Thank you to Reviewer 1 and 2 for the comments - below we have provided a line by line response to the reviewers' comments.

Reviewer 1 - Comments

FIG. S14. Shows the ISTS 65 dB SPL Response (dB SPL) Curve with Male 60-69 Left Ear Targets (dB SPL).

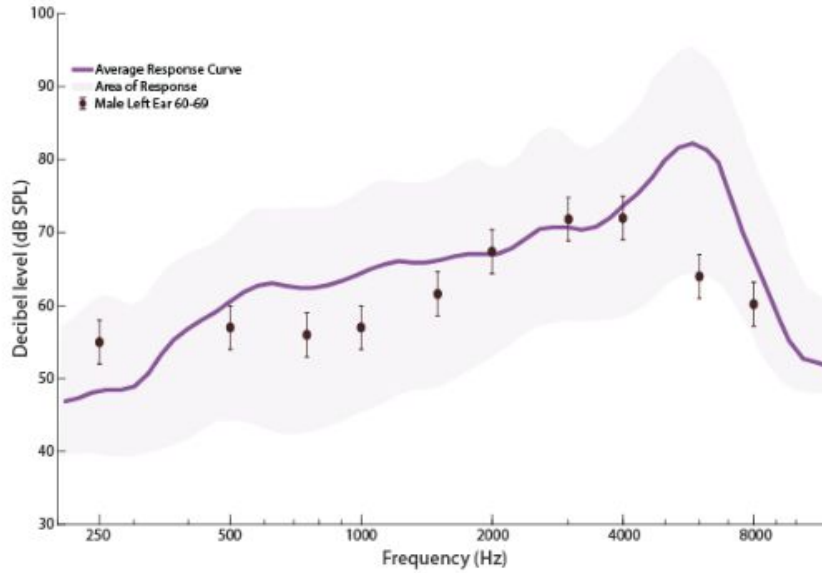
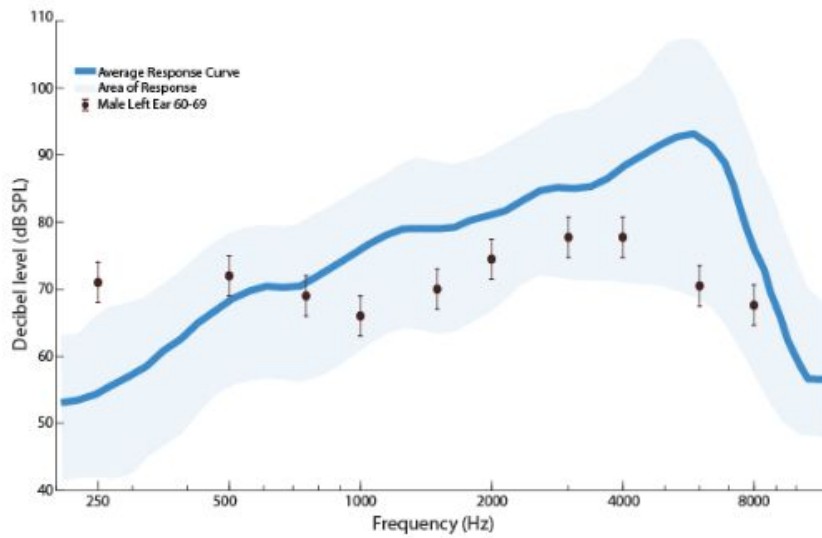
Figures 3 and 4b are almost impossible to read. I suggest creating multiple figures, one for male data, one for female data and one for hearing profile X, Y, Z data.

Screenshot from SI showing individual graphs. (we have figures for each profile separately in the SI).

We have furthermore added to figure captions in Figure 3 and Figure 4 the following sentence - The reader is referred to SI Figs S9-S79 and Tables I-LX for individual profile targets and responses.

FIG. S5. a Still from SI Movie 4 detailing drop test of the device. **b** Still from SI Movie 3 detailing water test of the device.

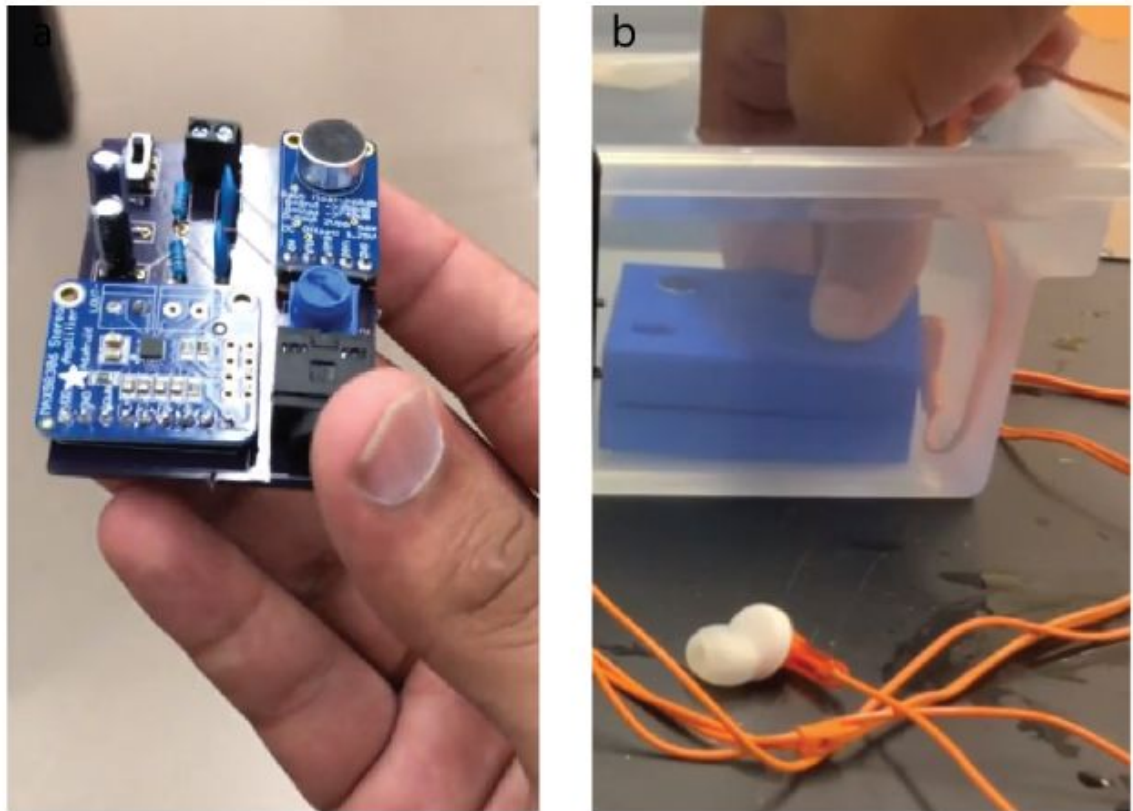
The video mentioned in line 98 (Video 4) should show the impact of LoCHAid from different perspectives;

- Please refer to SI Figure 5a. We had already shown a still from the video.

FIG. S8. A. Shows the front side view of the smaller version (1.05 x 0.81 in) of the LoCHAid. B. Shows the back side of the smaller version of the LoCHAid. It was assembled by third party fabrication house Macrofab (www.macrofab.com)

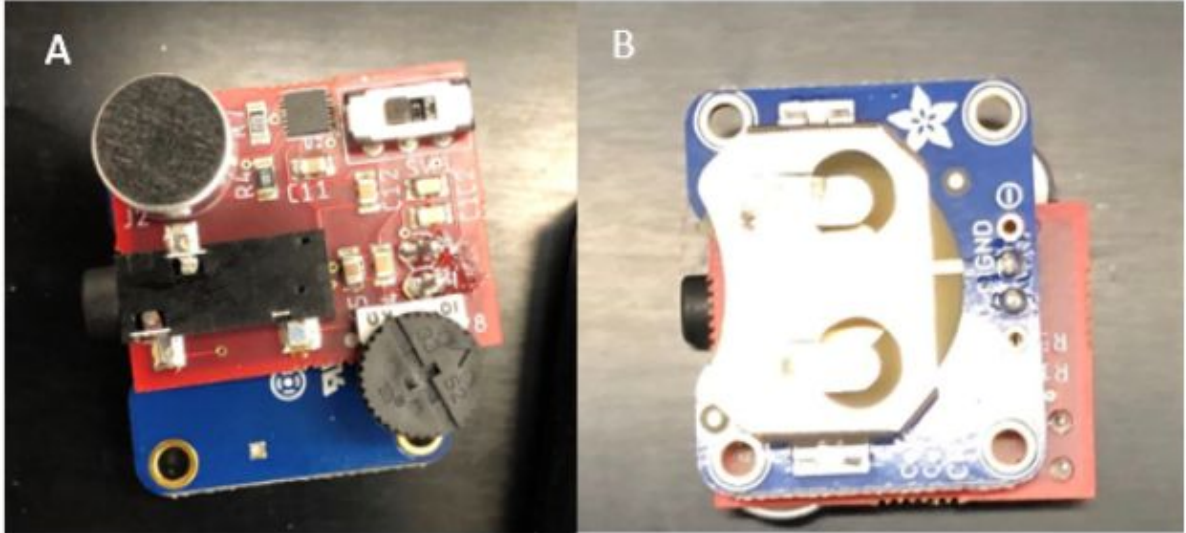
Line 289: About the smaller prototype, I suggest a figure that shows the final device.

- We have added a figure to SI - Figure S8 that shows front and back views of the small device.
